**MULTIPURPOSE DISASTER SHELTER PROJECT (MDSP)**  
**Monitoring & Evaluation (M&E) Consultant**

**FIELD VISIT REPORT**

1. Period of Visit : 21 November 2017
2. Location of Visit : Barisal District.
3. Participant of visit : A.H.M. Mahbubur Rahman, TL, M&E Consultant,  
Md. Matiur Rahman, Civil Engineer/ M&E Specialist, M&E Consultant,
4. Officials met during Visit :

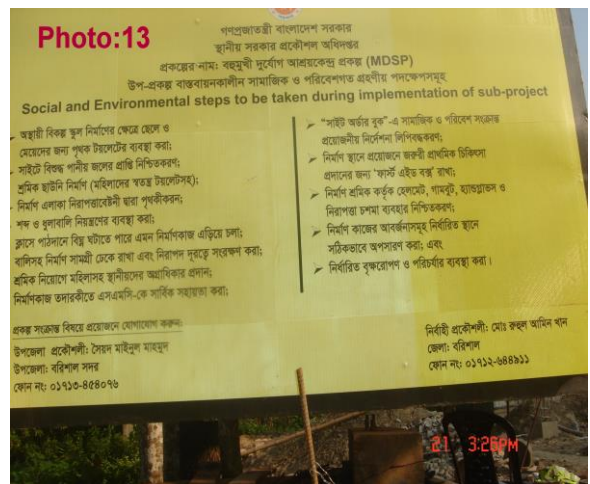
- **Uninterrupted Schooling:** There is provision of construction of temporary sheds for class accommodation where existing building has to be dismantled for construction works. This has been done. The temporary shed at **BP-246** is made of thatched fencing (**Photo:11**). Improved quality sheds should be made. During our visit of site at 10:30 hours, the Board conducted **Primary School Certificate Examination** was going on.
